September 2022 (Updated November 2022) | **Response to Comments**

4416 AZUSA CANYON ROAD

The propose of this document is to address comments received on the Initial Study/Mitigated Negative Declaration (IS/MND) for the 4416 Azusa Canyon Road project (proposed project) during and after the public review period. Section 2 responds to comment letters received during the public review period, which extended from December 21, 2021, through January 19, 2022. Section 3 includes responses to letters that were received after the public review period ended. Both sections show changes made to the IS/MND in response to these comments.

Figure 5 - Conceptual Site Plan

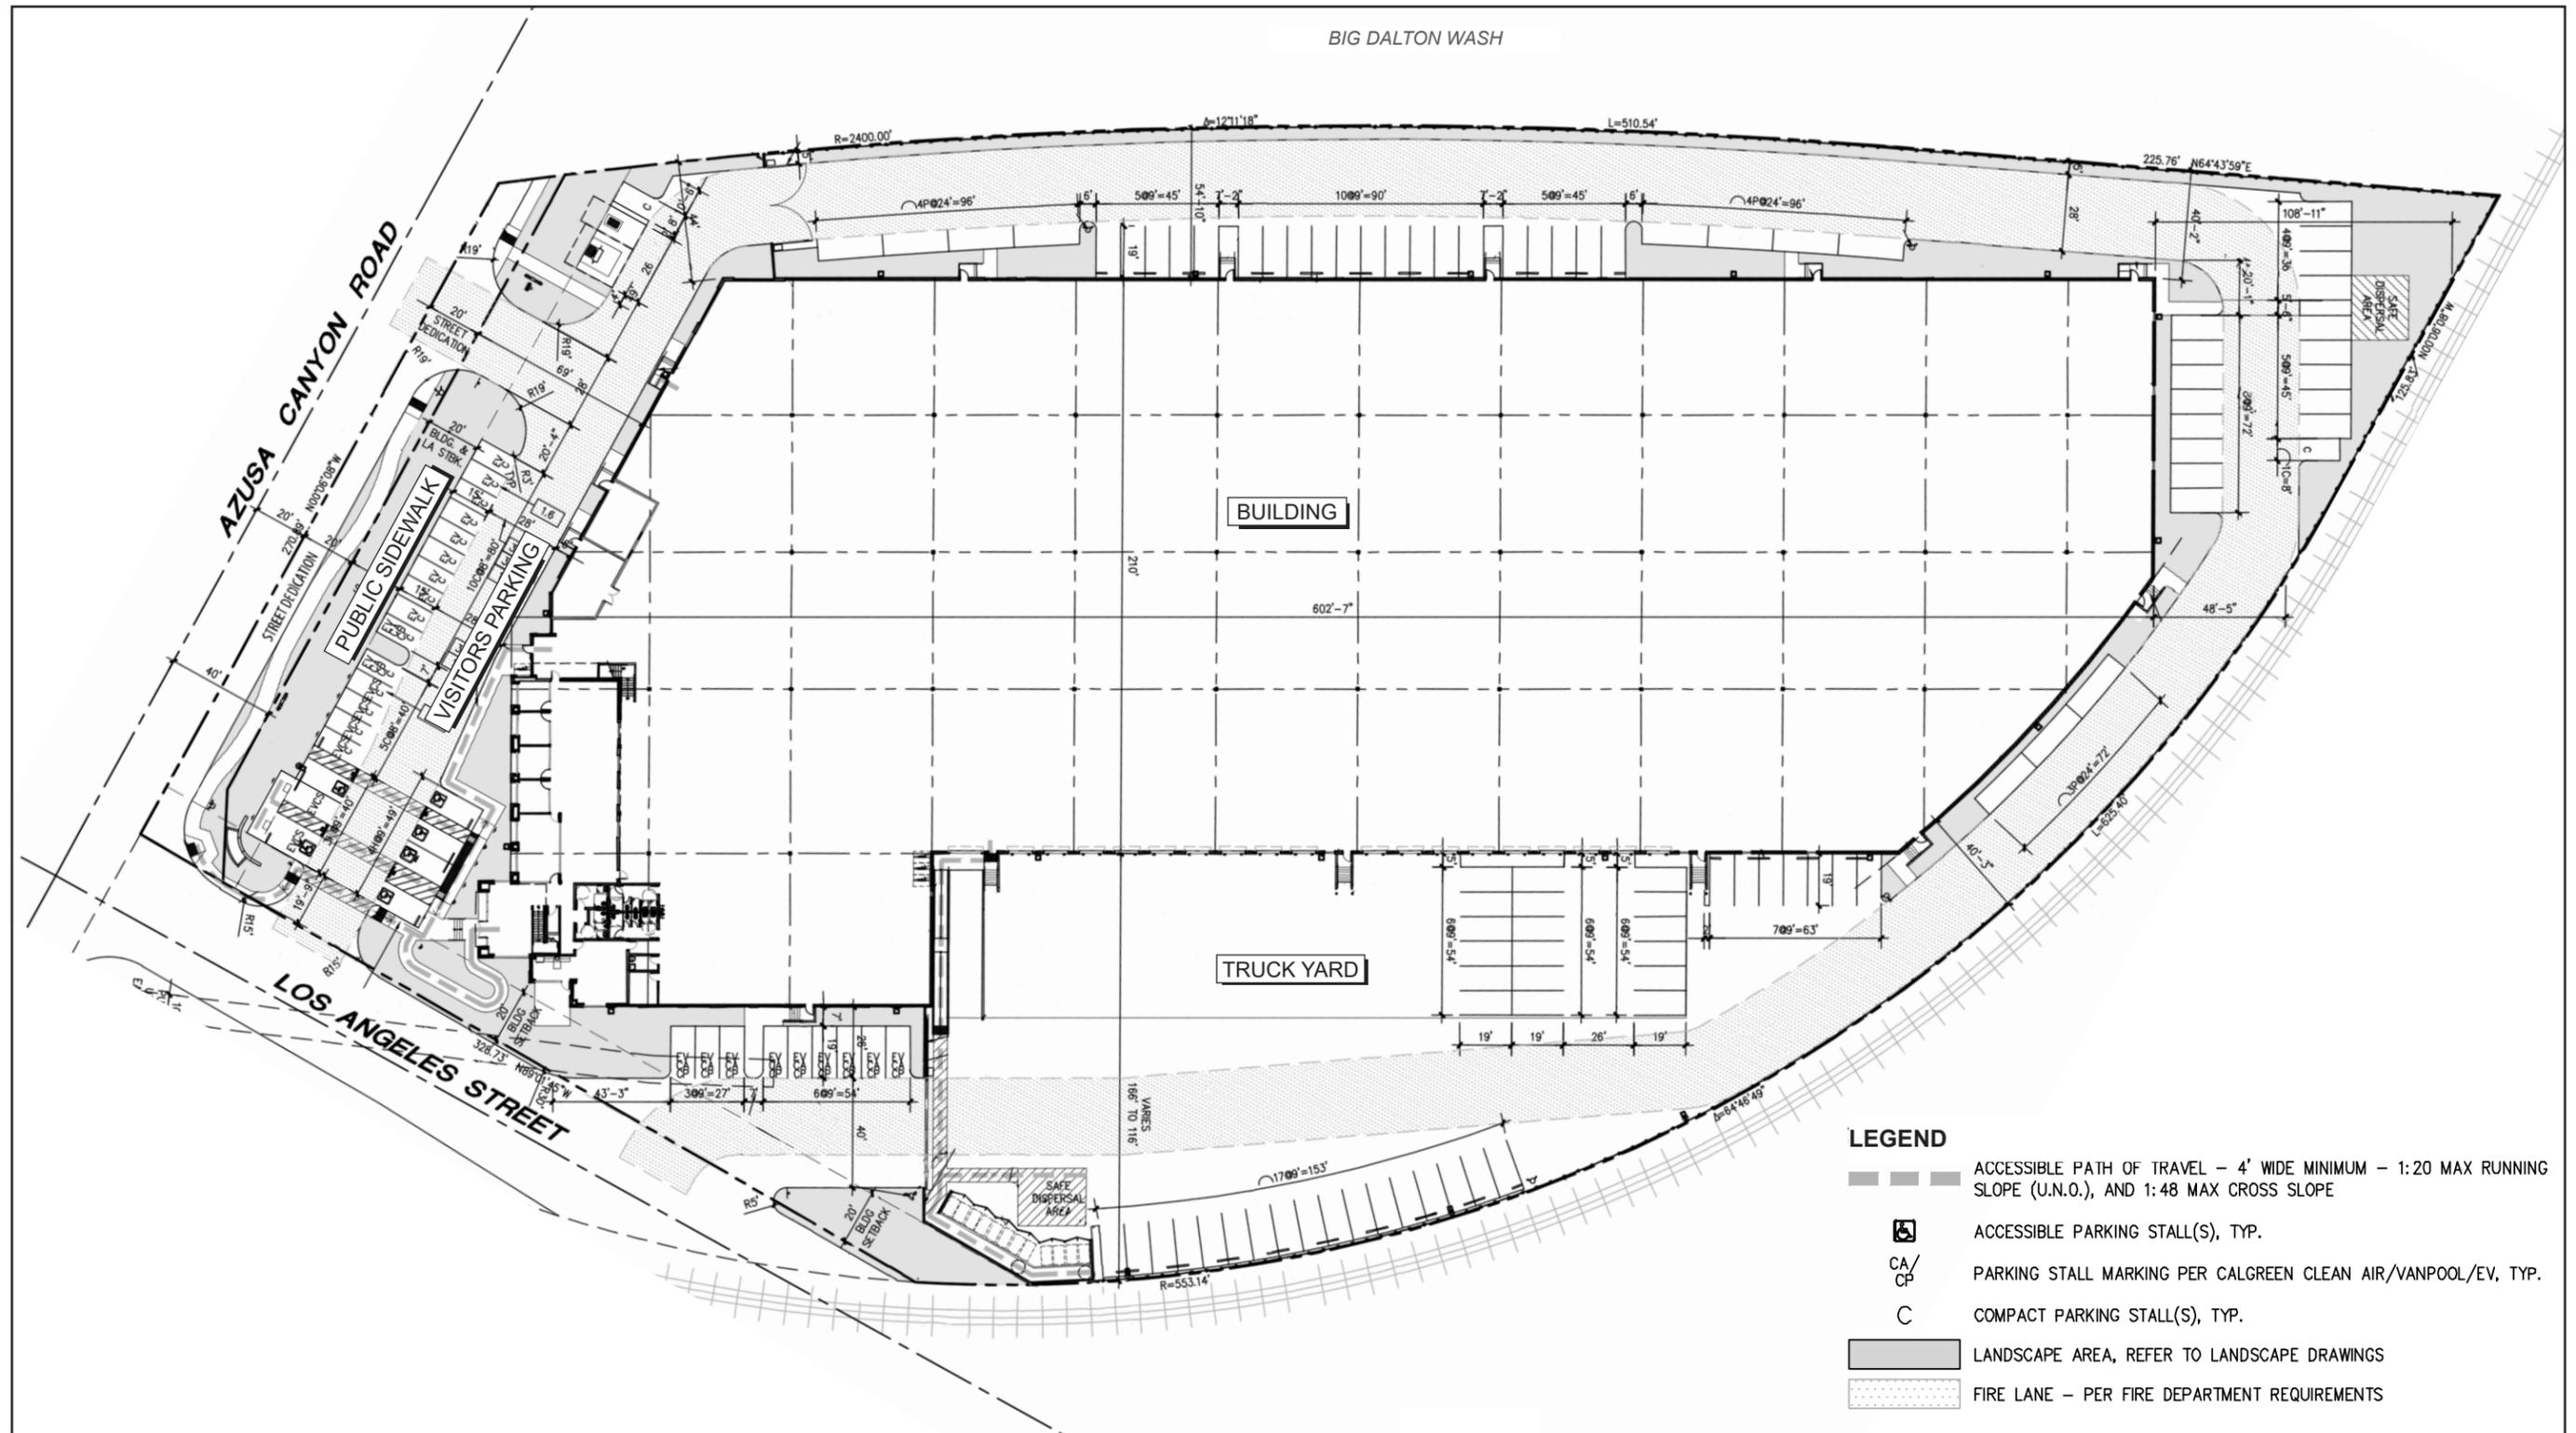
Page 15, Figure 5, Conceptual Site Plan. Figure 5 of the IS/MND has been replaced with the figure on the following page. Note also that the project’s Access Driveway refinement for the Azusa Canyon Road driveway is depicted in Exhibit 5, Appendix 6.

As shown in Figure 5, *Conceptual Site Plan*, vehicular access for the project site would be provided via three driveways: one off Azusa Canyon Road and two off Los Angeles Street. The driveway off Azusa Canyon Road and the western driveway off Los Angeles Street would provide access for employee/visitor vehicles and lead directly into the on-site parking areas for these users. Both driveways would connect to an internal drive aisle, which would lead to a rolling security gate—the gate would restrict access into the parking areas along the northeast and southeast sides of the building and in the truck court area to employees only. The internal drive aisles would also function as fire access lanes and provide a minimum unobstructed width of 28 feet. Trailer trucks would be ~~prohibited from using these driveways to access the truck yard; however, trailer trucks would~~ allowed to use the eastern Los Angeles Street driveway and the Azusa Canyon Road driveway to access the project site. The Los Angeles Street driveway would lead directly into the open yard via a rolling security gate. The driveway off Azusa Canyon Road would be restricted to ~~right-out/left-in~~ right-in/right-out only access,
